Technical Service Bulletin: TSB210013	Released Date: 22-Jan-2021
C500 D6RE Fault Code 5866 Harness Fix

C500 D6RE Fault Code 5866 Harness Fix

Figure 3, Harness relay circled in red

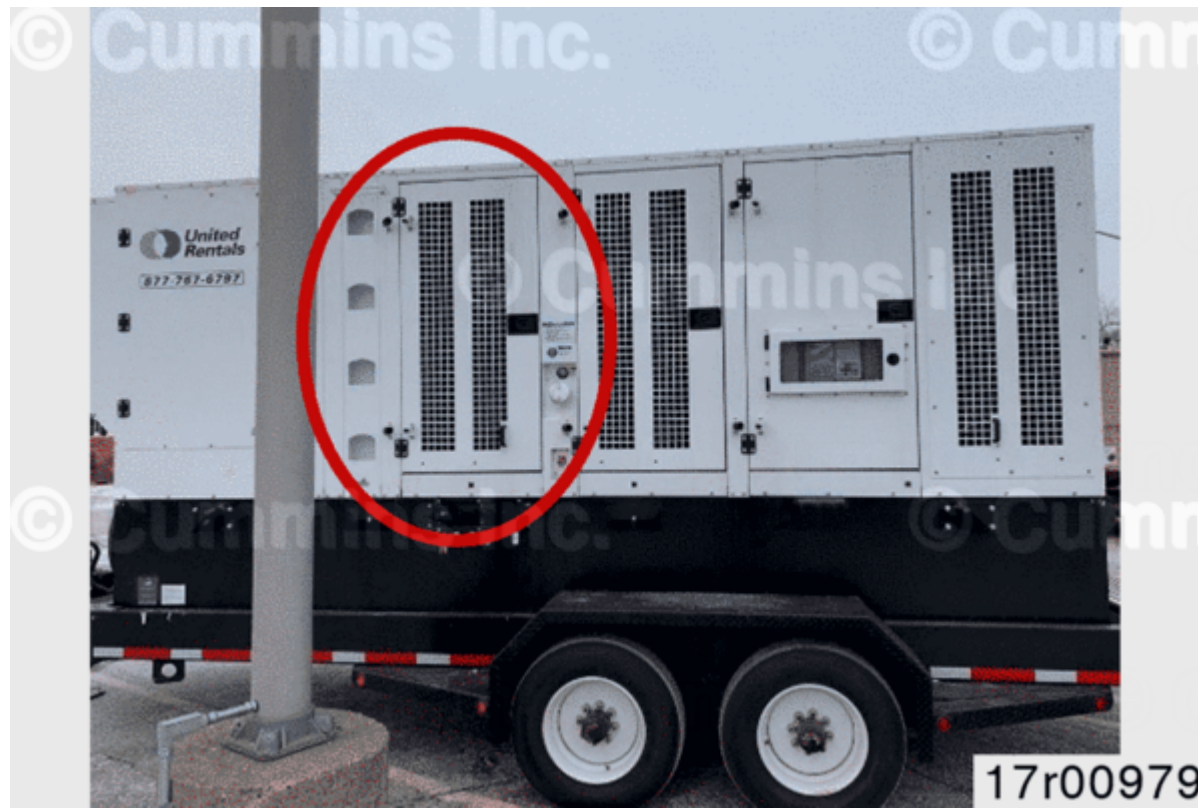
1. Identify Relay 5. Figures 1, 2, 3 show the location of the harness.

2. Using quick Splice for wire gauge, splice into wire 33 that connects to R5-87 pin.

Figure 5, Removed wire - taped to avoid short circuit

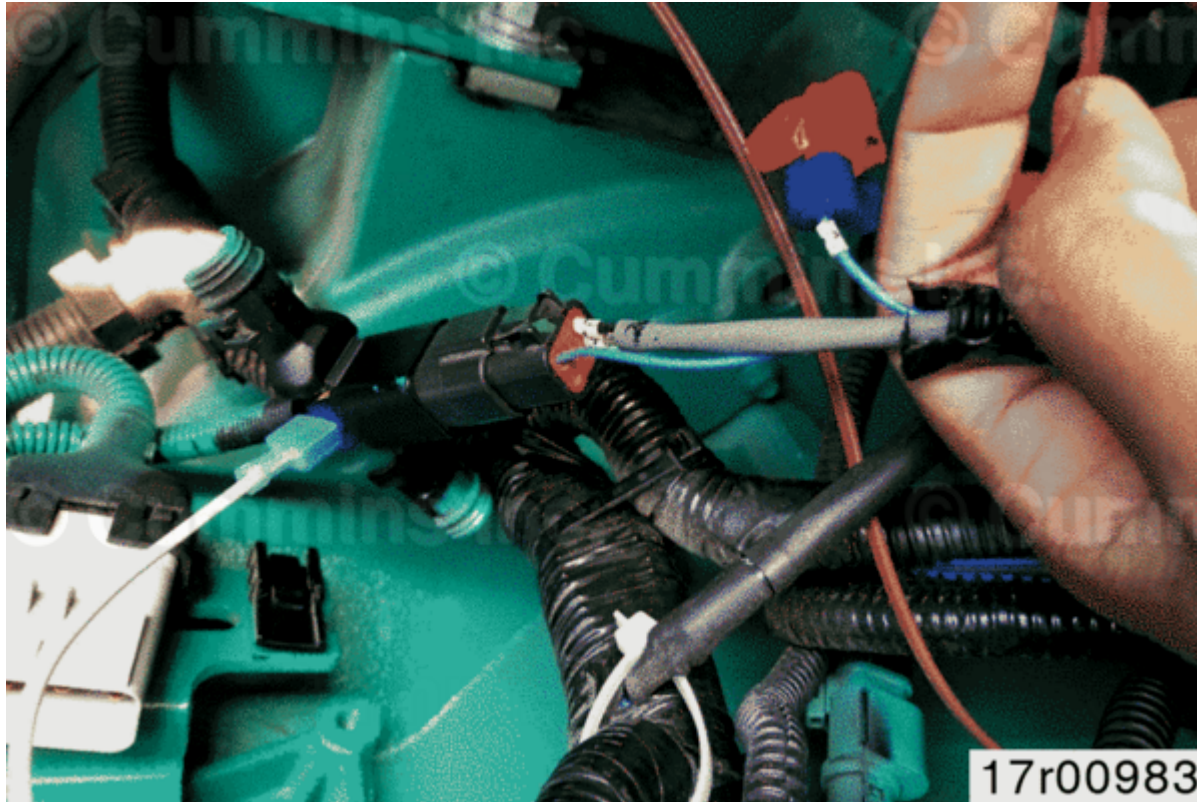
3. Remove wire going into pin 3 on CC4D.

3 a. Tape to avoid short circuit to metal parts.

4. Using quick splice for wire gauge. Splice into wire at CC4C pin 3.
5. Connect a new wire between splices.
